**VARIANCE / FIELD CHANGE NOTICE**

V/F: 21130-PSP-0001-6

PROJECT TITLE: Project Specific Plan for Area 9, Phase II Precertification Real-Time Scan

FIGURE 1. V/FCN 21130-PSP-0001-6

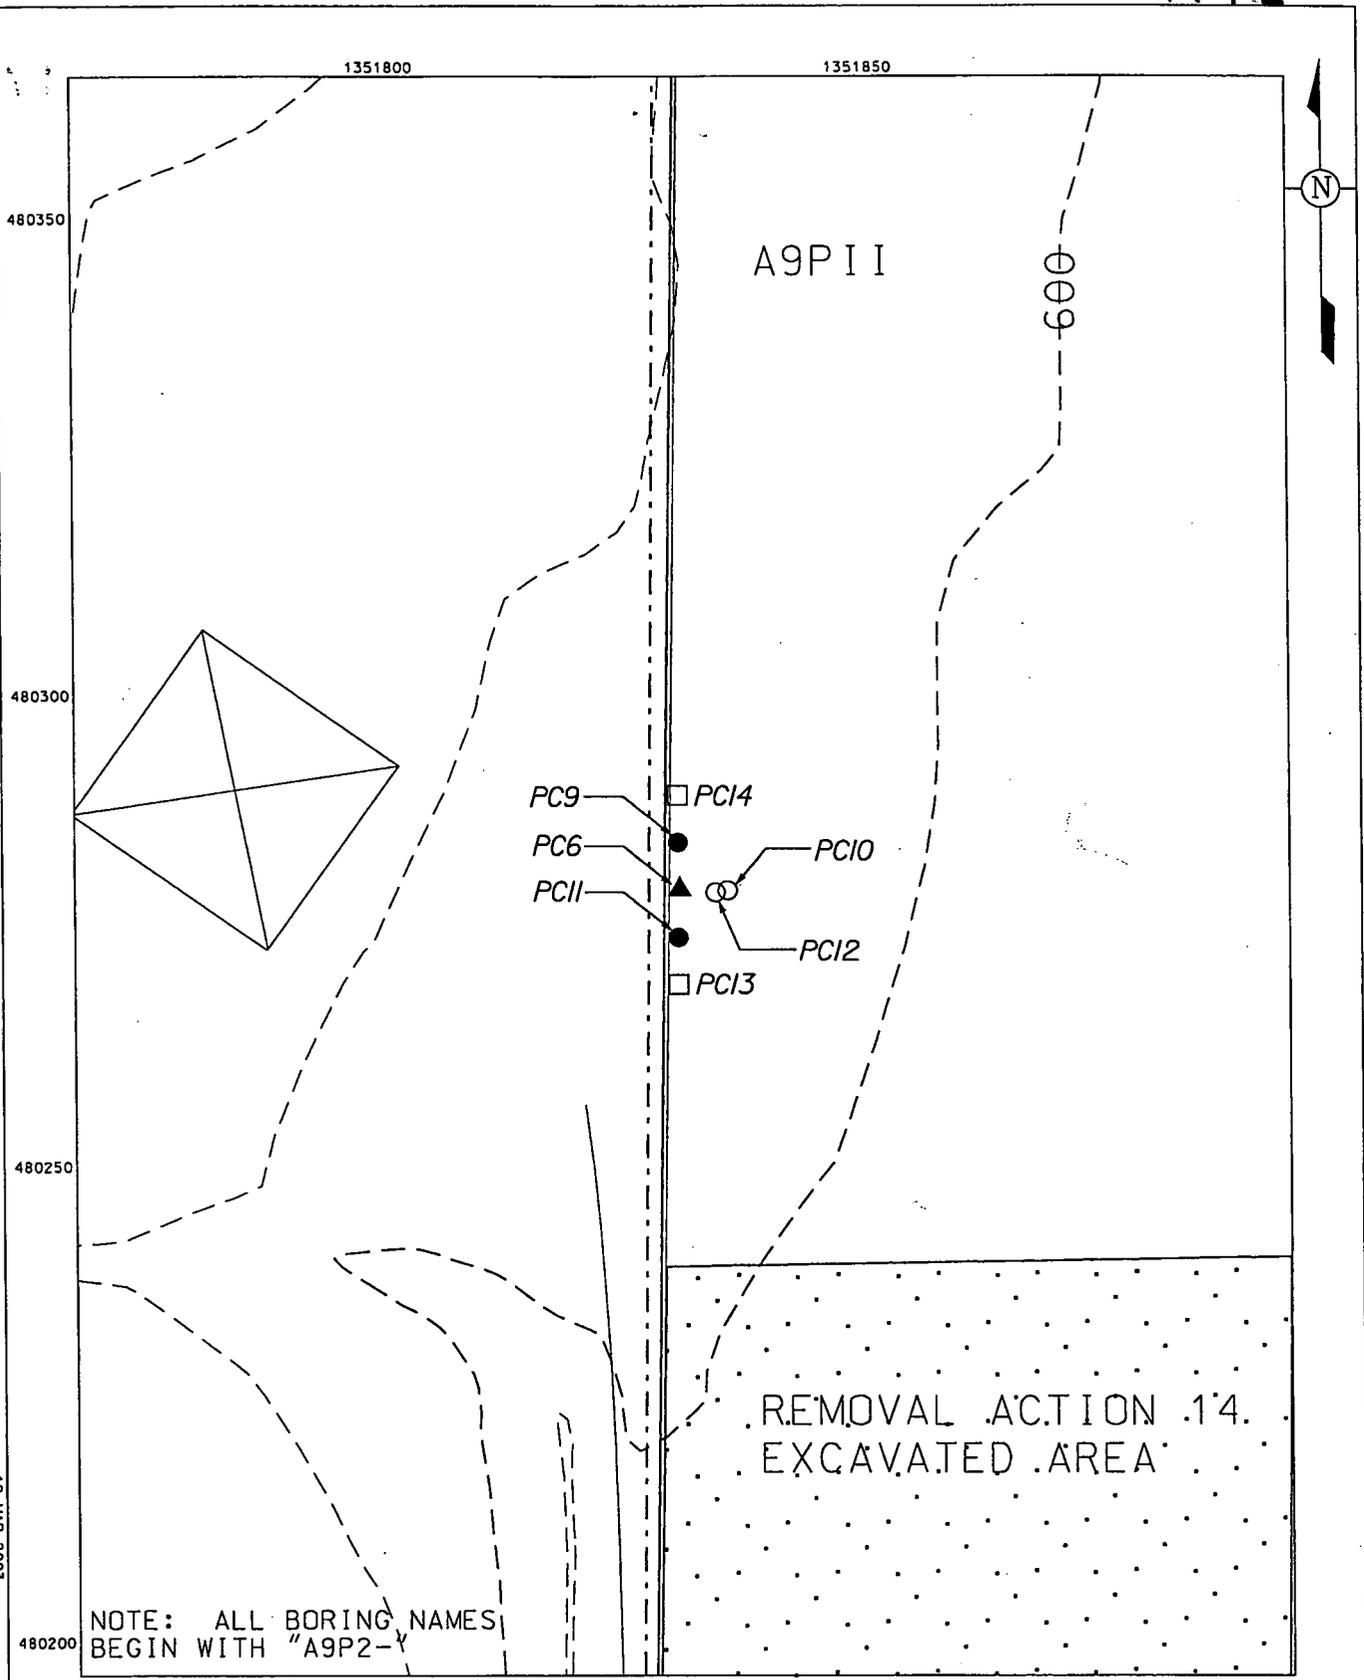
Boring A9P2-PC11 will be extended to a depth of 6.5 feet and samples will be collected at the 3.5 – 4 ft and 6 – 6.5 ft intervals. Borings A9P2-PC13 and A9P2-PC14 will be advanced to a depth of 3.5 feet and samples will be collected at the 0 – 0.5 ft and 3 – 3.5 ft intervals.

Boring A9P2-PC13 will be located 5 ft south of boring A9P2-PC11 and boring A9P2-PC14 will be located 5 ft north of boring A9P2-PC9. Samples to be collected under this V/FCN are identified on Attachment 2. See Figure 1 for sample locations.

Two samples collected under 21130-PSP-0001-4 indicated total uranium results greater than the FRL of 50 ppm. The total uranium result for sample A9P2-PC9^1-TU (0 – 0.5 ft interval) was 69.5 ppm and the result for sample A9P2-PC11^7-TU (3 – 3.5 ft interval) was 52.3 ppm. Additional samples are being collected to bound the "hot spot".
